DRB MEETING

Tuesday, May 20, 2025 at 7:00 PM

**SITE PLAN AMENDMENT  
Change of Building Envelope  
SA-001-25**

## SKETCH PLAN REVIEW Two-Lot Minor Subdivision SK-002-25

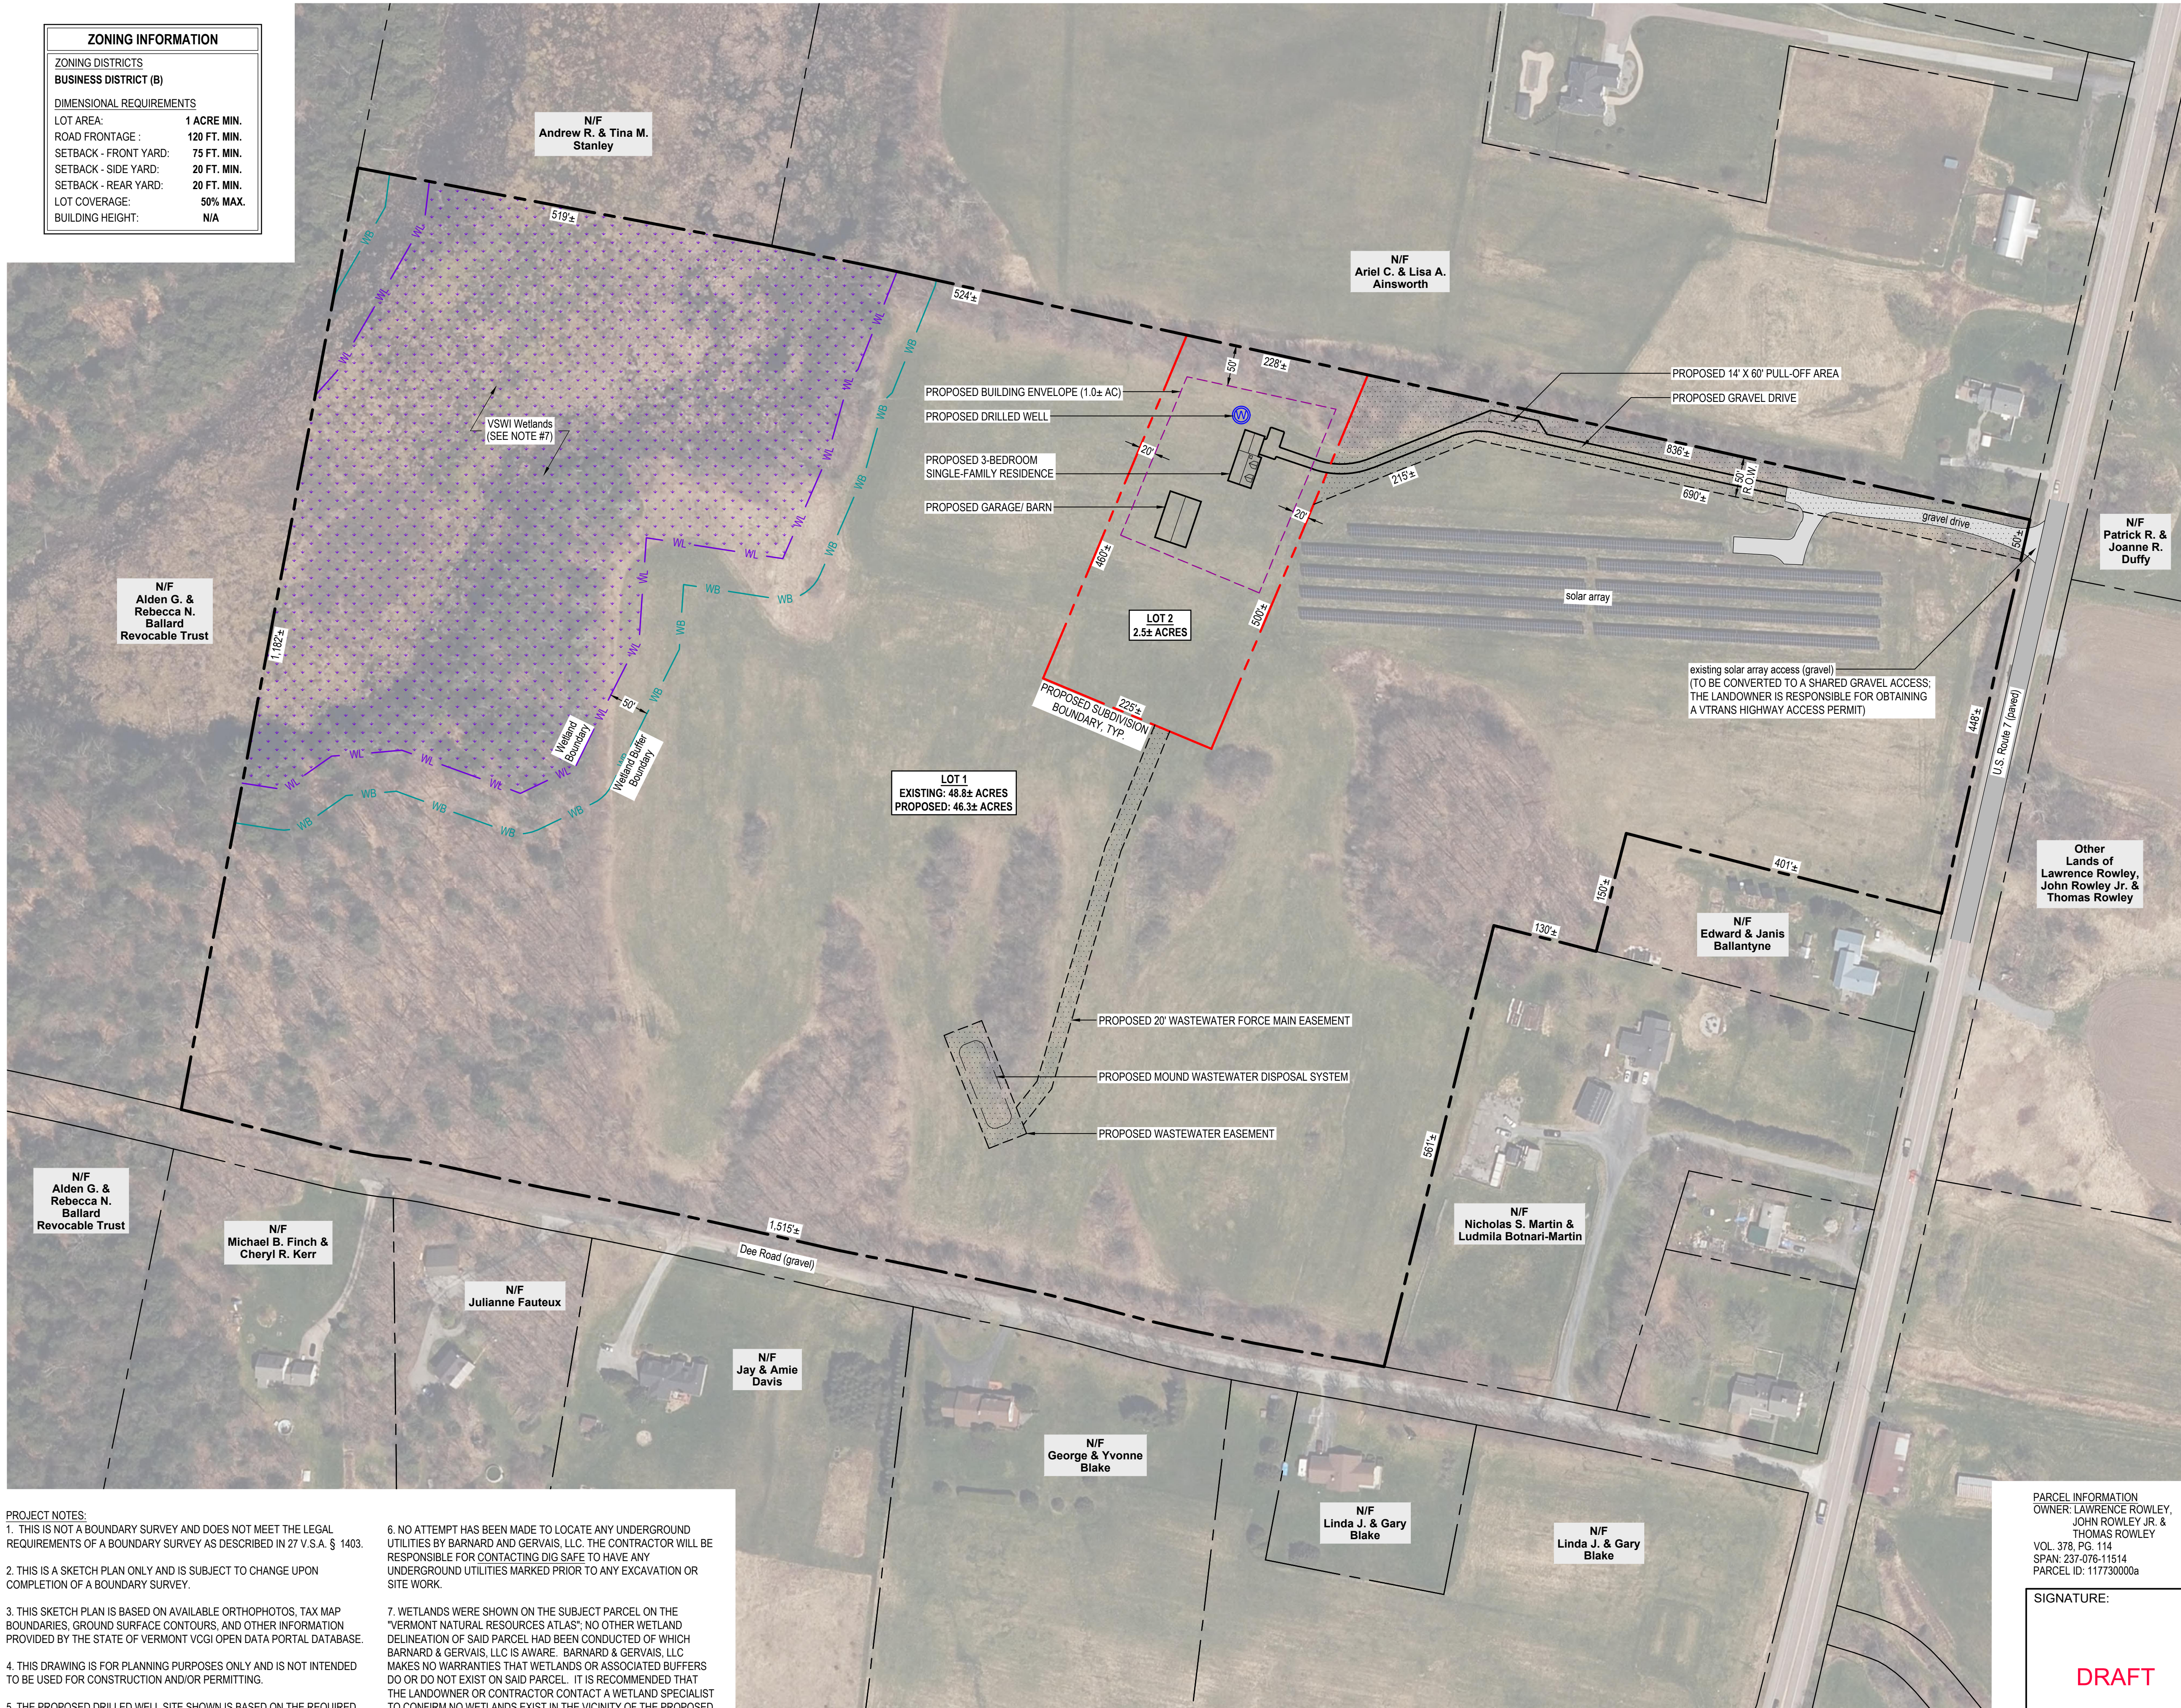
- 2. Site plans.** Applicant has submitted one map titled, “Sketch Plan” prepared by Barnard & Gervais, LLC on 4/6/2025 and labeled SK-1.

3. **Lot layout.** The proposed layout will divide the current lot into two lots, where Lot 2 will contain the proposed future dwelling and Lot 1 will remain vacant land. Under the proposed application. Lot 2 will not have any road frontage and will be served by a right-of-way through Lot 1 to Route 7. Either a Waiver for road frontage will be necessary or a change in the lot layout will be needed to include road frontage on Route 7.
